Class Rule Changes

International A's Youth Foil Class Association

Effective date: 06 Feb 2023

C.8 HULL APPENDAGES

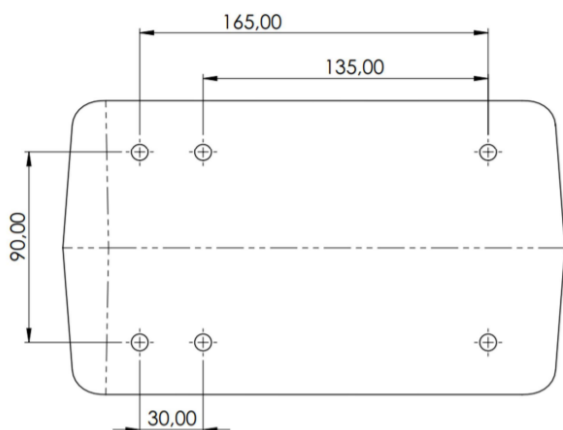
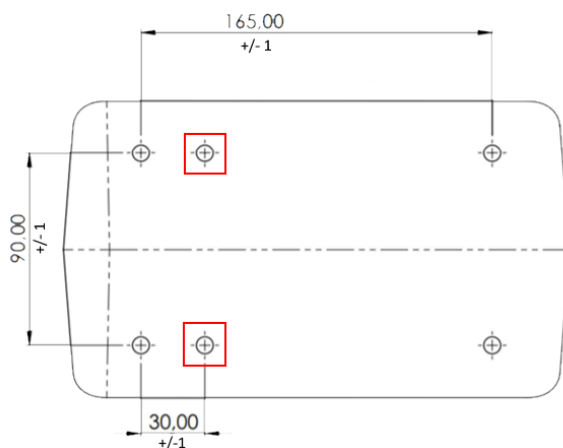
C.8.1(f) Two additional holes may be drilled in the mounting plate of the hydrofoil mast at the positions shown in the diagram:

C.8.1(f) Two additional holes may be drilled in the mounting plate of the hydrofoil mast at the positions shown in the diagram:
